Hamlet of Repulse Bay Water Licence No. 3BM-REP0409
Response to AANDC Review Comments, September 19, 2014

scale	NTS	PROJECT:	REPULSE BAY	project no. OTT-00207086A
date	01/12/14	TITLE:		
drawn by	IPC	WETLANDS LOCATION PLAN

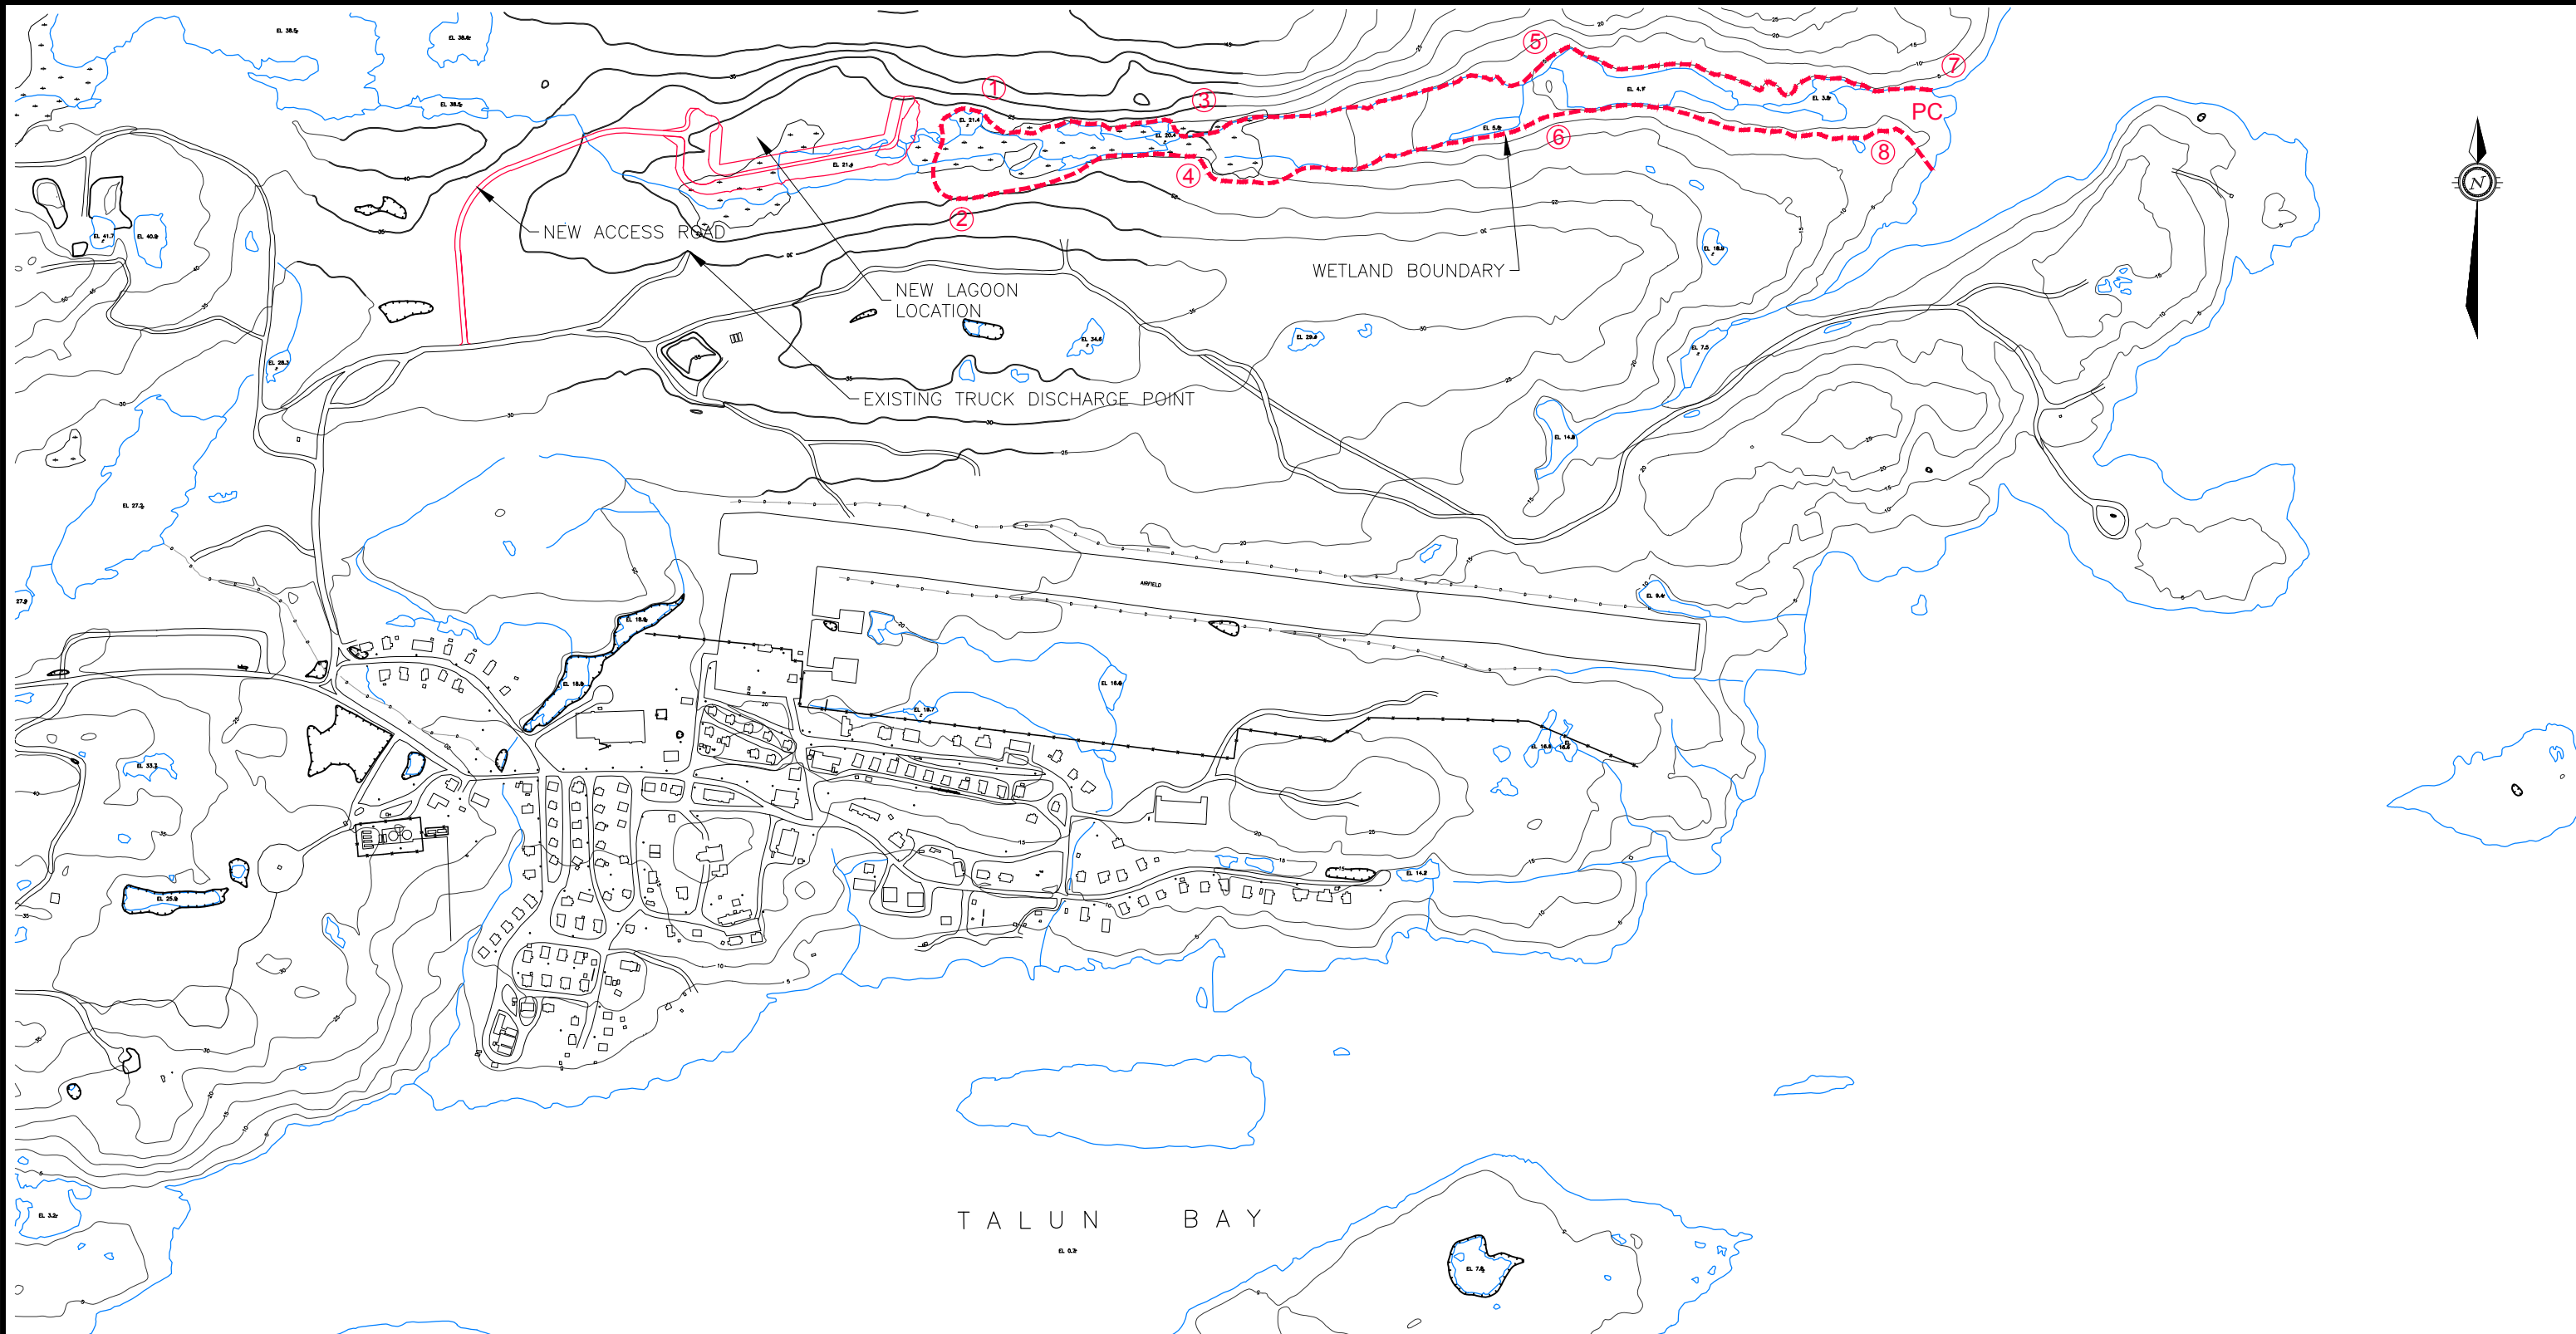
6	140214-3BM-REP0409 1310 Design Brief-ILAE	Wetland area	There seems to be no defined border for the wetland area.	If using the 'wetland' area between the sewage lagoon and the ocean as part of the treatment process, then the licensee should define the borders of their wetland area that is to be part of the sewage treatment facility. The defined borders will make it easier to assess the effectiveness of the use of the 'wetland', by, for example, monitoring effluent quality downstream of the treatment area.	The sewage treatment system was designed by exp Services to include a lagoon and wetlands area. The wetlands are part of the treatment process and as such the Final Discharge Point where effluent must meet compliance is within the wetlands area. Please see the attached Wetlands Location Plan drawing containing GPS coordinates for the boundary of the wetland area. The wetlands are naturally defined by the bedrock present on either side of the wetland area.
